TYPING AND NONTYPING REPERFORATORS TELETYPE MODEL 14

CHANGES }
No. 2 }

DEPARTMENT OF THE ARMY
WASHINGTON 25, D. C., 21 April 1952

TM 11-2223, 15 September 1947, is changed as follows:

Figure 143.1 (Added) Adjustable range scale (only on equipments starting with serial No. 73280).

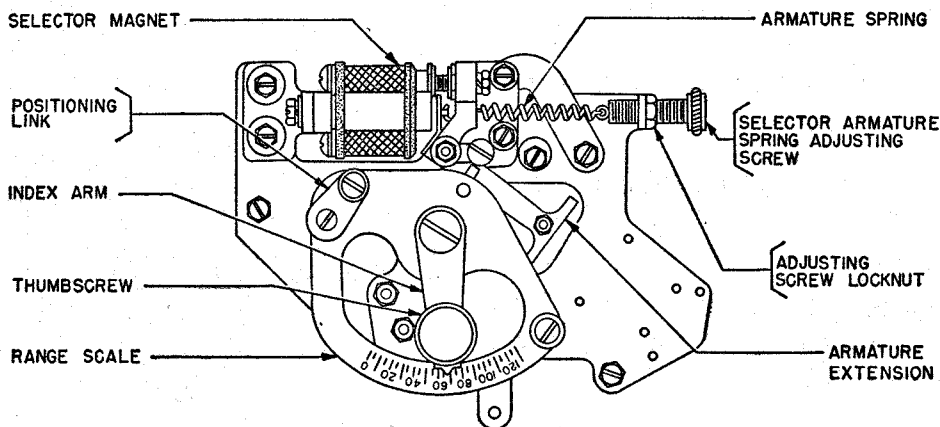
237.1 Selector Stop Arm and Stop-Lever Engagement (Pulling Magnet Selector) (fig. 1431.1) (Added)

Note. The following adjustment applies only to units equipped with the adjustable range scale assembly, starting with serial number No. 73280.

a. Preparation. With the selector magnet armature in the spacing position, rotate the selector can sleeve until the stop arm moves the stop lever to its maximum travel beyond the step of the trip latch. Loosen the range scale assembly mounting screws and positioning link mounting screw just enough to make the screws friction-tight.

b. Requirement. The overtravel of the stop lever beyond the trip latch is at least one-half, but

not more than the full width, of the stop lever. This should be checked with the index arm set 0, 60, and 120 on the range scale.

c. Adjustment. Position the range scale assembly to meet the requirement. Tighten the mounting screws and positioning link mounting screw.

259.1 Selector Stop Arm and Stop-Lever Engagement (Holding Magnet Selector) (fig. 143.1) (Added)

This adjustment applies only to units equipped with the adjustable range scale assembly starting with serial No. 73280. The adjustment is made in the same manner as outlined in paragraph 237.1.

Figure 266.2 (Added) Selector clutch torque nuts.

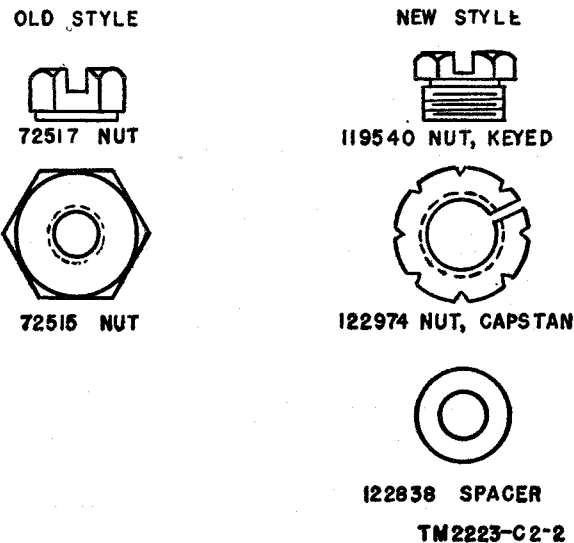
c. (Superseded) *Adjustment.* Check the condition of the felt washers and lubricate or replace them if necessary. If the requirement still is not met, proceed as follows:

- (1) On units up to and including serial No. 71306, the clutch torque may be adjusted by replacing the 72514 spring or by using shims between the 72515 nut and the spring. Shims are available under the following numbers: 96763 (.012 inch thick), 96764 (.016 inch thick), and 96765 (.020 inch thick).
- (2) Each unit starting with serial No. 71307 has an adjustable capstan nut (122974). To adjust the selector clutch torque, position the capstan nut (fig. 266.2).
